TE Connectivity

Product Change Notification: PCN-22-142289

SFP-DD 1X1 SMT connector

After EC, remove the SI tuning bar (Section A-A view)

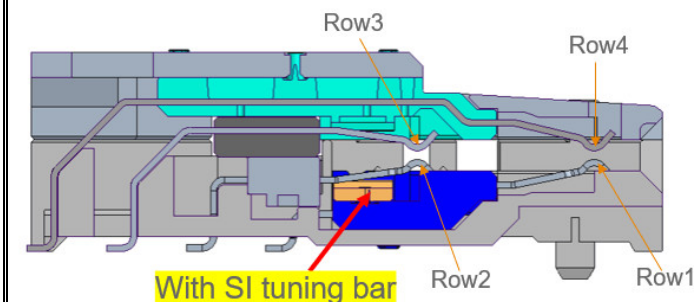
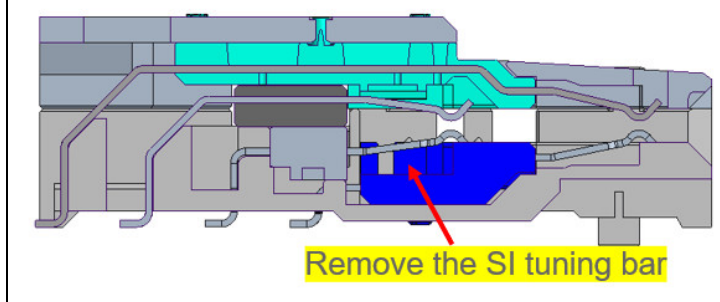
Please be aware the listed parts have some update (not affecting performance and specification of product). Before: There is a SI tuning bar between Row1 and Row2 wafer. After: Remove this component

Before EC, there is a SI tuning bar between Row1 and row2 wafer

Before EC, there is a SI tuning bar between Row1 and row2 wafer

After EC, remove the SI tuning bar

Due to Row1 and Row 2 are used for low speed signal transmission, removing this component does not impact SI performance but can improve manufacturing productivity.
